ADDENDUM NO. 2

WASHINGTON STATE PARKS AND RECREATION COMMISSION KOPACHUCK STATE PARK DAY USE DEVELOPMENT SW-C1811

DATE: April 22, 2024

DWG NO/SHEET: 1 of 1 / E1.04
 DRAWING TITLE:
**SITE ELECTRICAL
 PLAN - GRID 4**

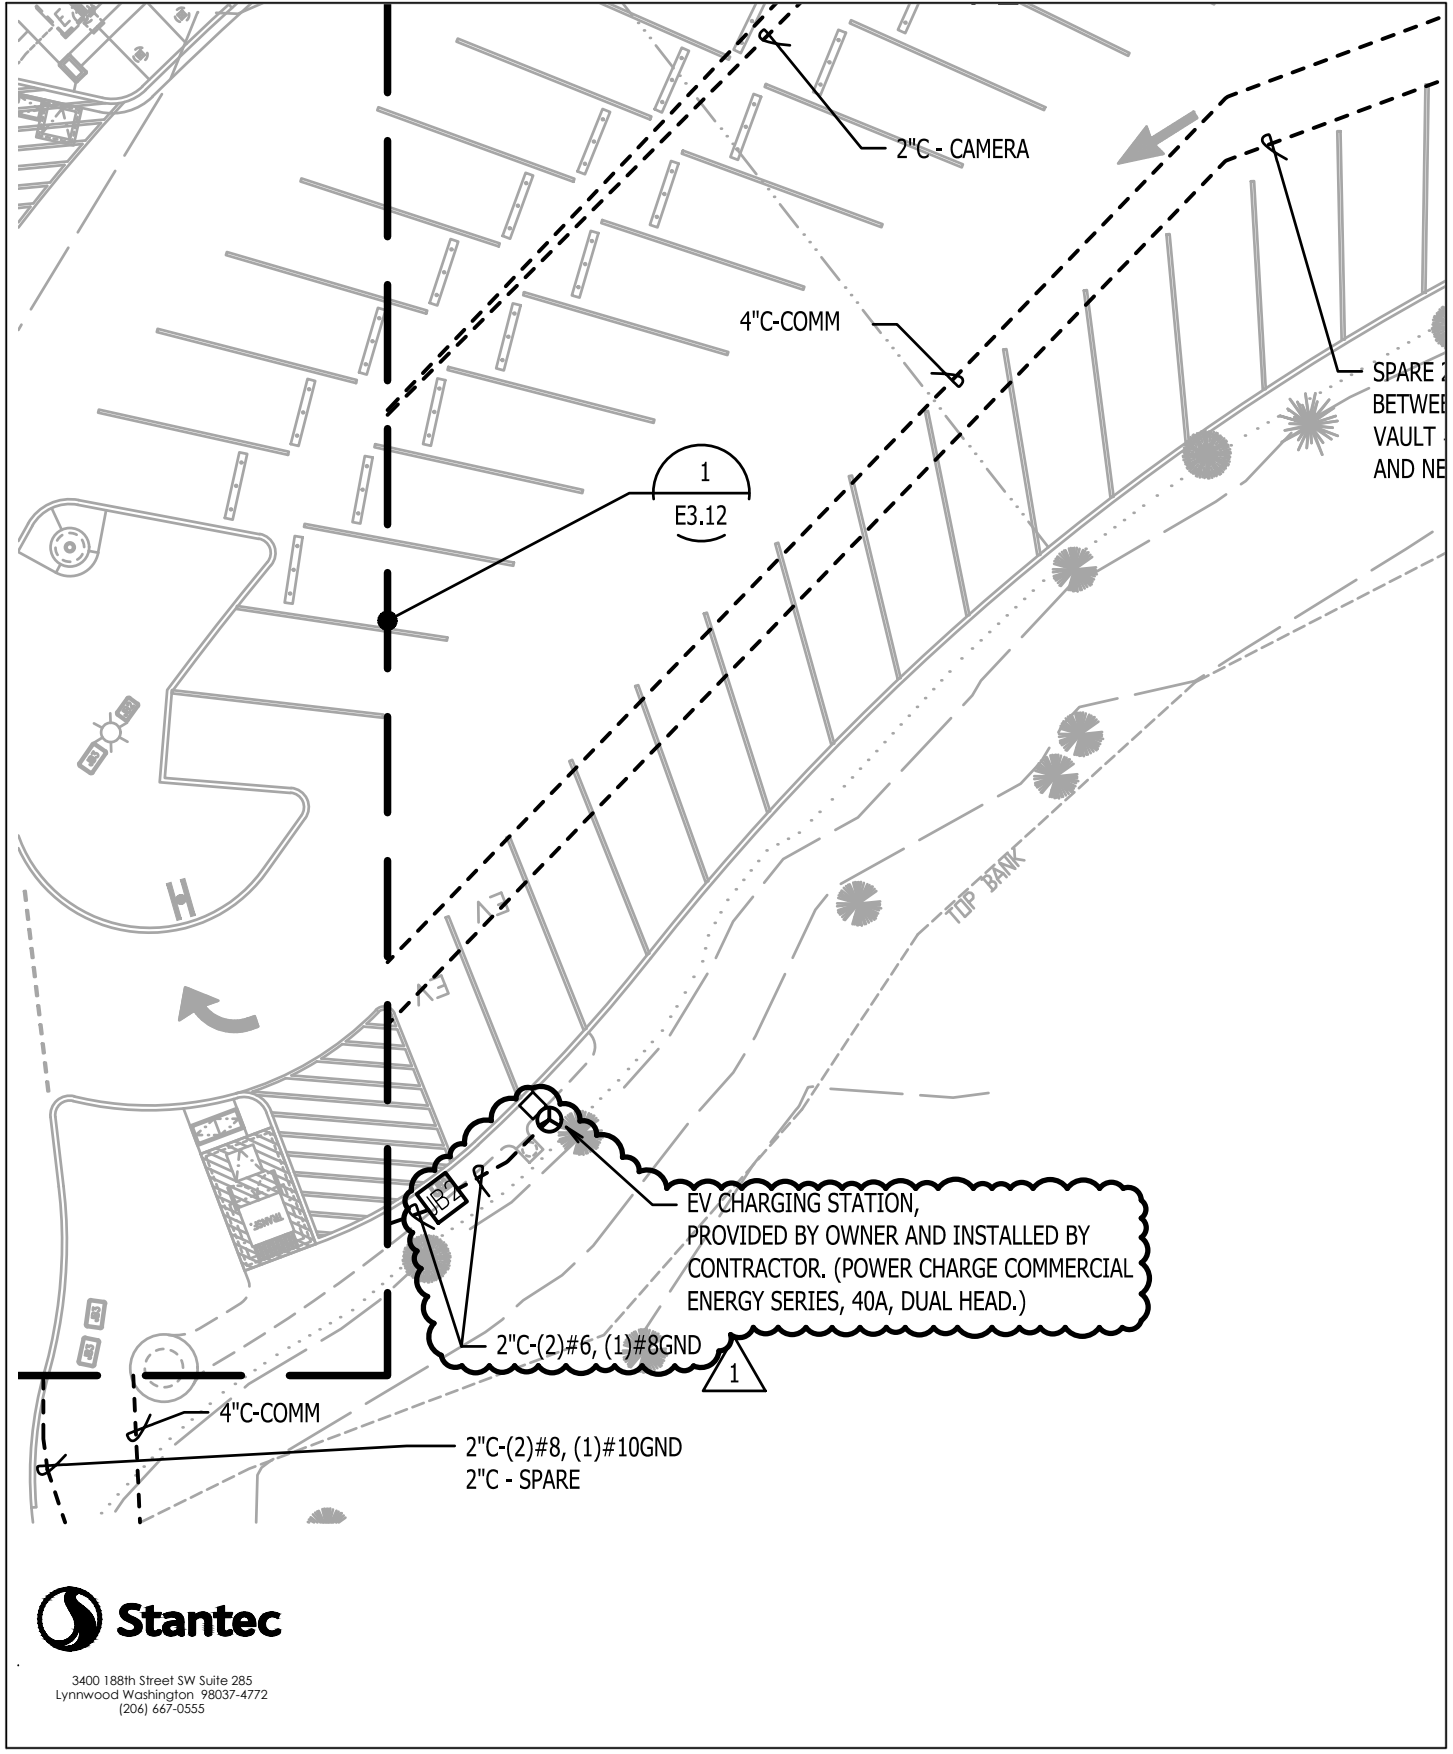
Sheet E1.04: **Revise:** EV Charger quantity and location as shown clouded on Addendum Sketch ADD-2.06 attached.

We are looking at bidding the electrical on the Kopachuck State Park Day Use Development project and noticed on sheet E1.04 it calls out for 2x EV Chargers to be installed. Does the state have a preferred brand / unit that they use or is it up to the contractor to submit on one of the typical brands and install? I’m not seeing anything called out in the specs or the state web site.

Site Drawing # E1-04 shows (2) EV Chargers. Can you please send additional information: Brands, Single/Double Head, including Network Subscription. Or is only Conduit Stub-up for Future EV Chargers? Please confirm.

The EV Charger will be an Owner furnished, Contractor installed single, pedestal mount, dual charger with cable retractors. See revisions to 1.1 COMMISSION FURNISHED ITEMS in Section 016000 – PRODUCT REQUIREMENTS of the specifications as noted above. The specific brand to be installed will be: PowerCharge Platinum Charging Station, Pedestal mount, Dual Port, 208/240v, 40a (9.6kW), 18’, J1772, OCPP 1.6 (WIFI Capable), Includes Cable Retractors. See PowerCharge product data cutsheet attached. For EV Charger location see revisions to Layout & Materials Plan Enlargement as shown on Addendum Sketch ADD-2.05 and Electrical Site Plan – Grid 4 as shown clouded on Addendum Sketch ADD-2.06 attached. For Electrical Panel see revisions to Welcome Center Panel Schedules & One-Line plan as shown clouded on Addendum Sketch ADD-2.07 attached.

The EV Charger will be an Owner furnished, Contractor installed single, pedestal mount, dual charger with cable retractors. See revisions to 1.1 COMMISSION FURNISHED ITEMS in Section 016000 – PRODUCT REQUIREMENTS of the specifications as noted above. The specific brand to be installed will be: PowerCharge Platinum Charging Station, Pedestal mount, Dual Port, 208/240v, 40a (9.6kW), 18’, J1772, OCPP 1.6 (WIFI Capable), Includes Cable Retractors. See PowerCharge product data cutsheet attached. For EV Charger location see revisions to Layout & Materials Plan Enlargement as shown on Addendum Sketch ADD-2.05 and Electrical Site Plan – Grid 4 as shown clouded on Addendum Sketch ADD-2.06 attached. For Electrical Panel see revisions to Welcome Center Panel Schedules & One-Line plan as shown clouded on Addendum Sketch ADD-2.07 attached.
